Determination 2007/71

A dispute in relation to the issue of a notice to fix for retaining walls at Nos 36, 36A, 38, and 38A Normans Hill Road, Onehunga, Auckland

Figure 1: Site layout taken from the unit title plan

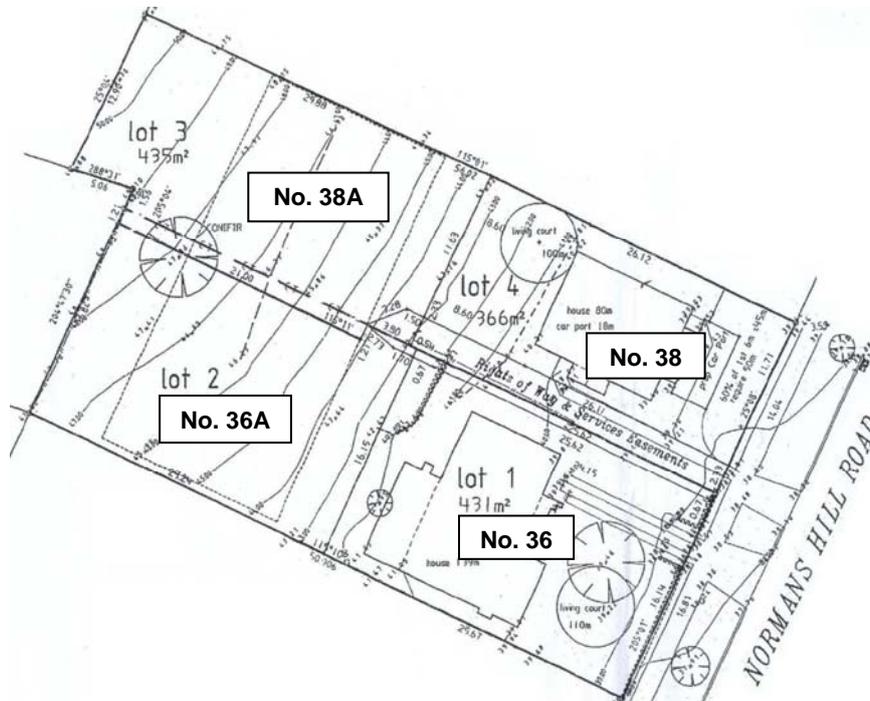
- 2.1 The building work consists of retaining walls constructed on 4 separate properties. There are two parallel retaining walls, supporting a concrete driveway slab, that run along the entire end boundaries of Nos 36 and 38 and for a short distance along the end boundaries of Nos 36A and 38A. The driveway slab gradient rises from the road and its height above the natural ground level along the retaining walls varies from zero at each end to a maximum of approximately 1500mm at the centre. The supporting retaining walls are constructed with circular timber poles concreted into drilled holes and which support timber walings installed above the ground level. No safety barriers are installed along either of these walls.

5.4.1 The expert noted the absence of the driveway safety barrier that was shown on the consented plans. The tops of retaining walls were more than 1 metre above the ground levels for a length of 10.5 metres along the boundary with No 36 and for 10.8 metres along the boundary with No 38. The maximum fall-heights are 1.25 metres for the No 36 wall and 1.45 metres for the No 38 wall.

5.5.1 The expert noted that part of this retaining wall has "bowed" slightly towards the lower (No 36) property and some of the posts within this section have a slight tilt forwards. While the expert did not think that the wall was failing at this time, he was of the opinion that it is not performing as intended. The wall appears to be "under-designed" as the diameter of the poles is less than expected taking into account their spacing. In addition, the embedded depth of the poles is unknown. The expert observed that, as the retained height varies between 0.7 and 1.2 metres and does not support any surcharge, this particular wall did not require a building consent. (I observe, though, that section 7 of the 1991 Act requires that all building work complies with the Building Code, regardless of whether it requires a building consent).

5.6.1 The expert noted that some of the concrete paving slabs behind the retaining wall between Nos 36 and 36A have moved. In addition, one saw cut in the slab at this location has opened up. The expert attributed this movement to the fact that the slabs are on both sloping and filled ground. Where the slab has lifted, the expert was of the opinion that this was not necessarily related to retaining wall movement but rather to the settlement of the fill material under the slab.

- 7.2 The expert’s investigation has established that there is a length of each of the driveway retaining walls that are not protected where the possible fall exceeds 1 metre. I note also that the consented plans detail a barrier for the driveway. The lack of a protective barrier at these two locations means that in this respect, the driveway does not comply with clause F.4.3.1.

- 7.3 The concerns raised by the expert regarding the structural stability of the retaining wall between Nos 36 and 36A leads me to believe that this particular retaining wall does not appear to meet the performance requirements of B1.3.1. The expert has stated that, as the height of this retaining wall above the lower ground level is less than 1.5 metres, it did not require a building consent. Subject to the earlier qualification note in paragraph 2.1, while I agree with this opinion, the wall still needs to comply with the Building Code. I endorse the recommendation of the expert that further investigation of the wall is required because it may not comply with clause B1 of the Building Code.

8.2 I also conclude that the territorial authority must withdraw its notice to fix and issue new notices that deal only with the remediation of the retaining wall between Nos 36 and 36A and the lack of a safety barrier to the driveway where the fall height exceeds 1 metre. Such notices should be sent individually to each property owner with details that are only relevant to each property.
